Application for Certification (15-AFC-01)

Puente Power Project (P3)
Oxnard, CA

Responses to City of Oxnard Data Requests Set 5

REVISED FIGURE 49-3

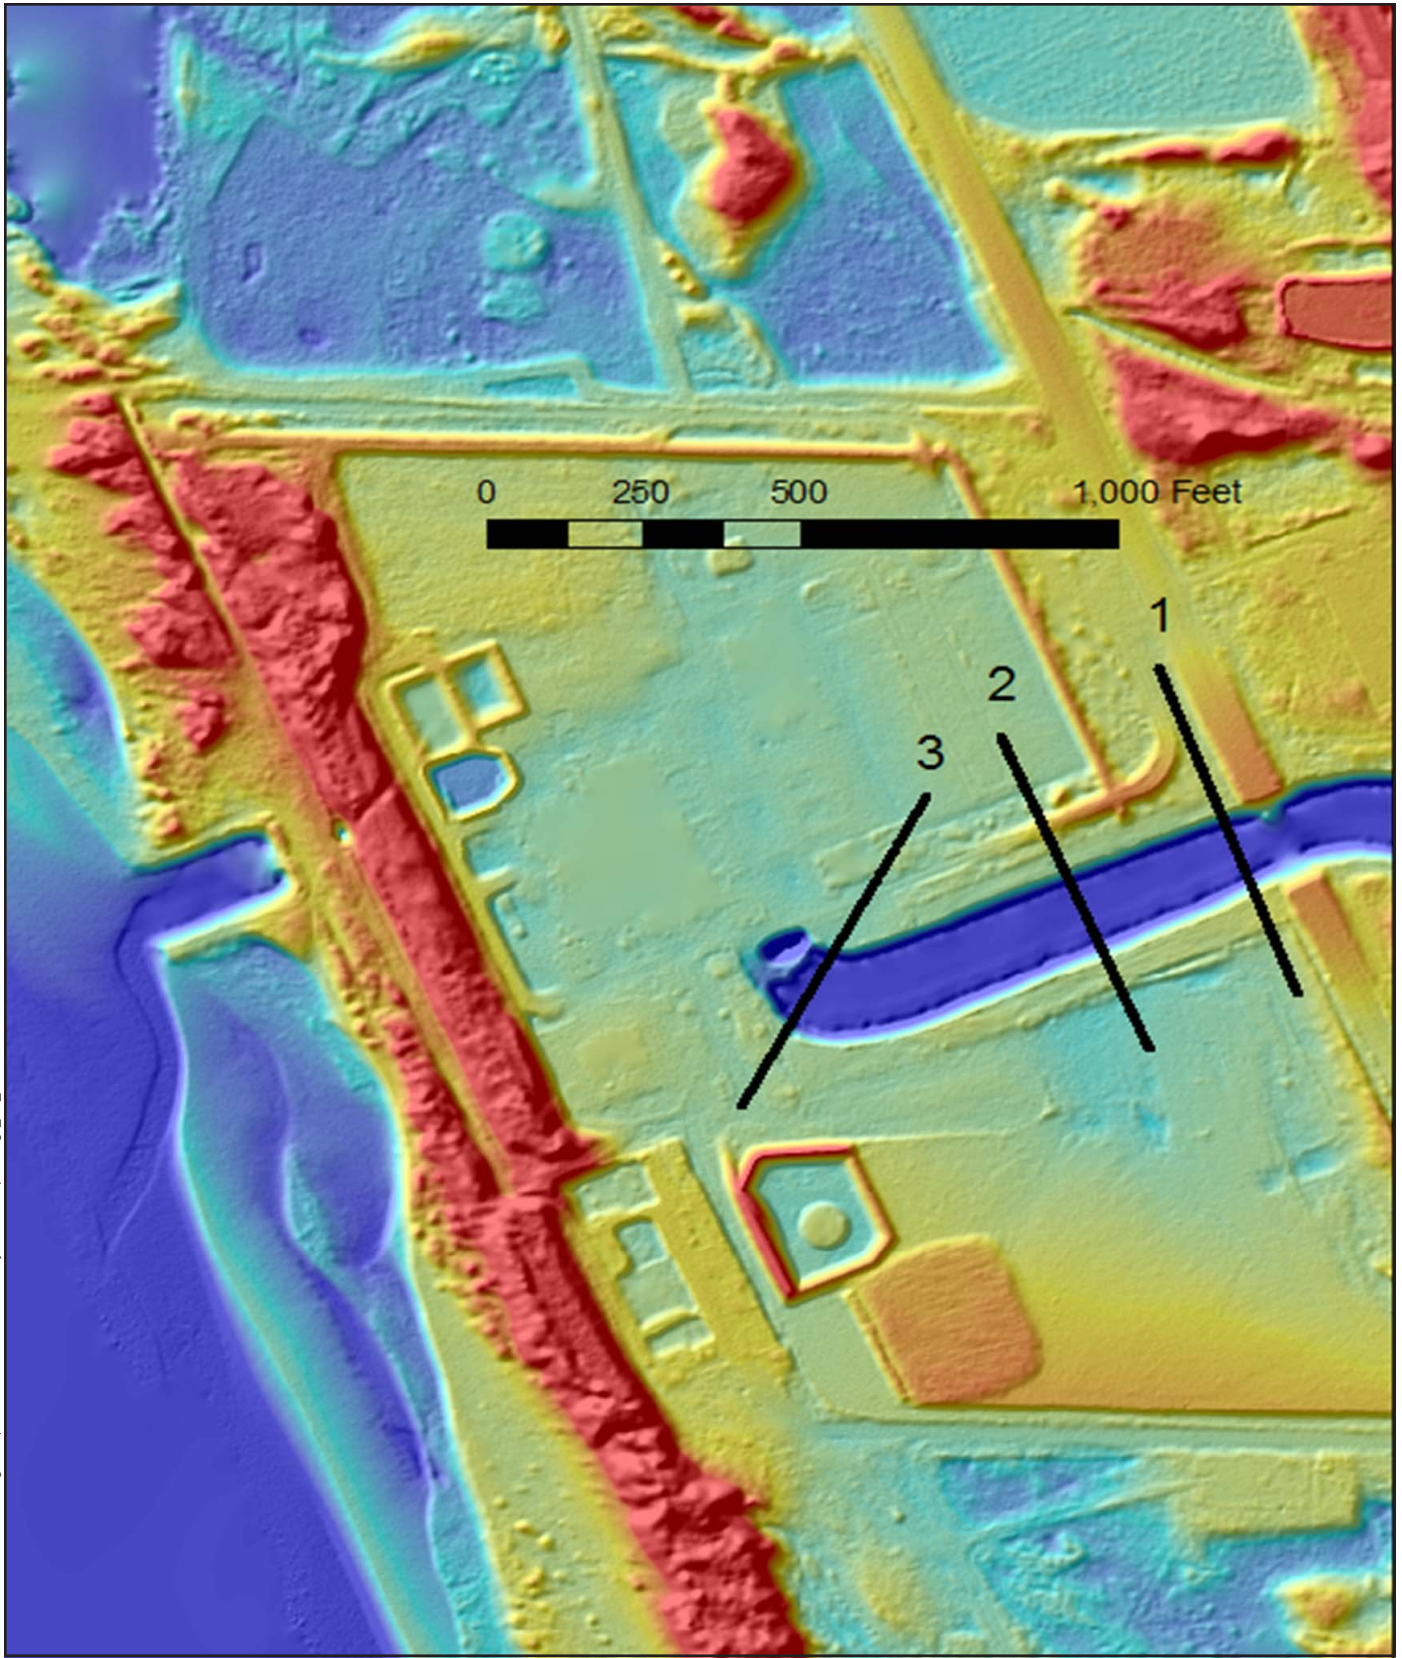
96. ***Some of the figures included in the applicant's data responses still lack information that is needed to interpret these figures. For instance, it is not clear the date that the LIDAR data was collected. Previous responses to this data request have referred to the 2013 merged LIDAR however this is the date of the data product, not the date of collection. In addition, while the image in Figure 54-2 contains elevation contours, those contours stop before the right-hand edge of the image. Consequently, the image lacks full elevation contours for either the project site or even the crest of the dunes. Please reproduce Figure 54-2 with a full set of elevation contours for the entire image. Please also reproduce Figure 49-3 with a legend.***

Figure 49-3 shows the locations of the three canal profiles shown on the graph in Figure 49-2. Please see revised Figure 49-3 with a legend added.

FIGURE 99-1

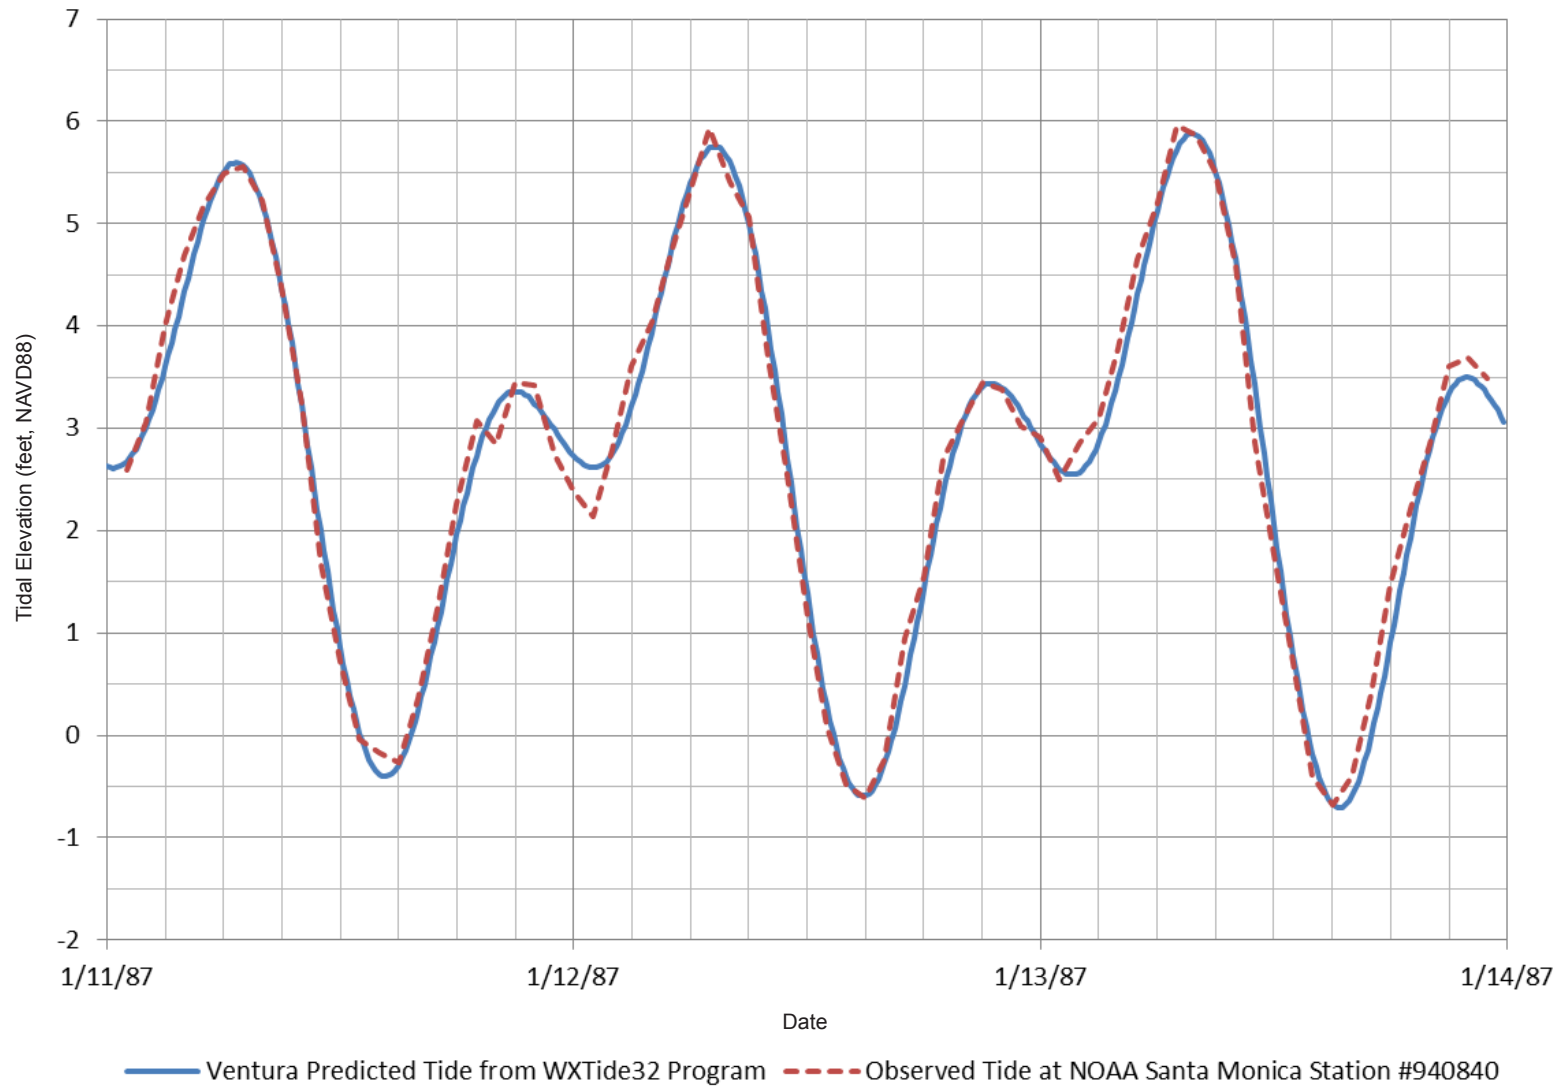
99. The applicant’s response to City Data Request 89 refers to photographs contained in Appendices 64-1 and 90-1. Please provide the date and if available timestamps for these photographs as well as any available information about the tide and wave conditions at the date and time that these photographs were taken.

The photographs included in Appendices 64-1 and 90-1 are dated, but the timestamps are unknown; therefore, the tidal conditions for the day of the photograph are provided in Table 99-1. Tidal information for the tide station at Santa Barbara (nearest station to Project site) is unavailable before 2005; therefore, the tidal data from the tide station at Santa Monica were used from 1987 to present. Prior to 1987, no nearby tidal gage data are available; therefore, the predicted tide from the program WXTide32 (available online at: <http://wxtide32.com/>) was used. As shown on Figure 99-1, the tidal prediction from WXTide32, when compared to the observed tide at Santa Monica for January 11, 1987, through January 14, 1987, provides similar results.
